Sundry Print Reports
02/25/2025

Well Name: NE SQ LAKE PREM Well Location: T16S / R31E / SEC 9 / County or Parish/State: EDDY /

Notice of Intent

Type of Action: Plug and Abandonment

North East Square Lake Premier Unit 13 Field: North East Square Lake Lease: NMNM04421 API #30-015-04827 9-16S-31E, Eddy County, NM 660' FNL & 1980' FEL Wellbore Status as of :

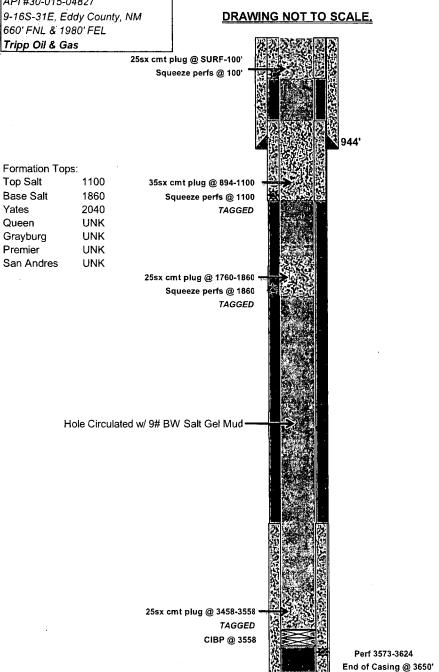
Created By	Condition	Condition Date
loren.diede	Notify the OCD inspection supervisor via email 24 hours prior to beginning Plug & Abandon (P&A) operations.	3/20/2025
loren.diede	A CBL is to be run after setting the CIBP at 3558'. Submit the CBL tif file to the NMOCD for upload into the Well Log File.	3/20/2025
loren.diede	Please note: Plug depth revisions as noted by NMOCD conditional approval dated 12-4-2019.	3/20/2025
loren.diede	In addition to the NMOCD revised plug depths dated 12-4-2019: Add cement plugs as follows: Greyberg formation top, perf at 3308', squeeze cement to 3208', Queen formation top, perf at 2920', squeeze cement to 2820', Yates formation top, perf at 2090', squeeze cement to 1990'.	3/20/2025
loren.diede	This well is within the LPCH restricted area and a below ground P&A marker is required. Submit a photo and GPS coordinates of the P&A marker with the subsequent P&A report.	3/20/2025
